**CITY OF VANCOUVER
DEVELOPMENT, BUILDINGS, & LICENSING**

**DEVELOPMENT PERMIT STAFF COMMITTEE
MEETING
December 6, 2023**

**990 Beatty Street (COMPLETE APPLICATION)
DP-2023-00631 – CD-1**

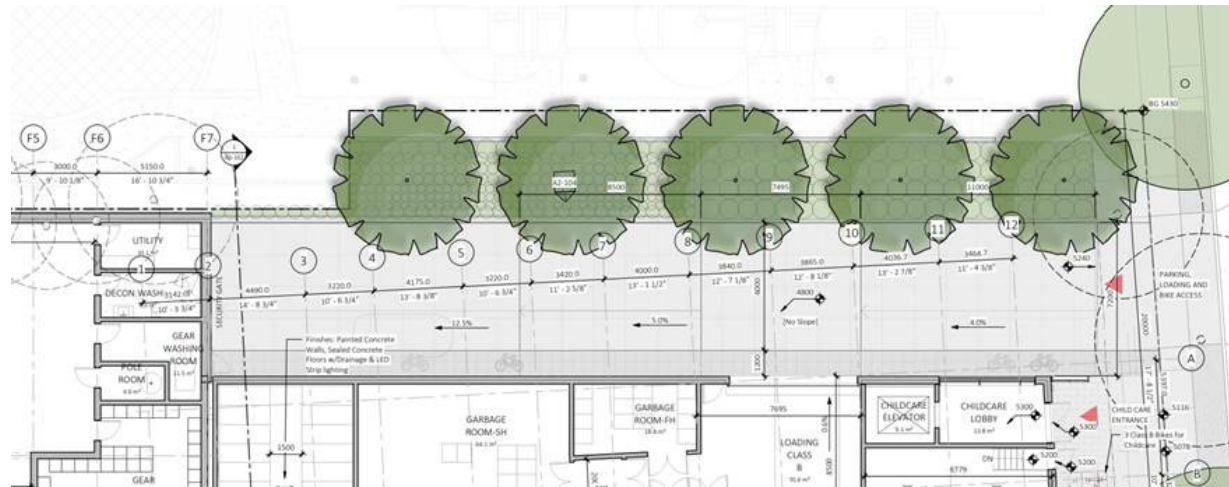
I live in a loft townhouses that will be facing the proposed development. In the plans it looks like the path in front of my home is going to be reduced in width by the development. Is this the case? And if so, what will the access to our homes look like?

In the diagram it also looks like the driveway into the parade of the proposed development is going to be directly in front of my home. Is this driveway going to be covered? Is it going to be going underground or will the cars be driving above ground directly in front of my home?

Staff Response: The driveway into the parkade is not expected to be covered and will mostly be at-grade sloping down into the P1 level as you travel further into the property. There is proposed landscaping & trees between the driveway and the townhomes per the screenshot below. It looks like the neighboring site's walkway is encroaching on the 990 Beatty property but will be retained according to the drawing.
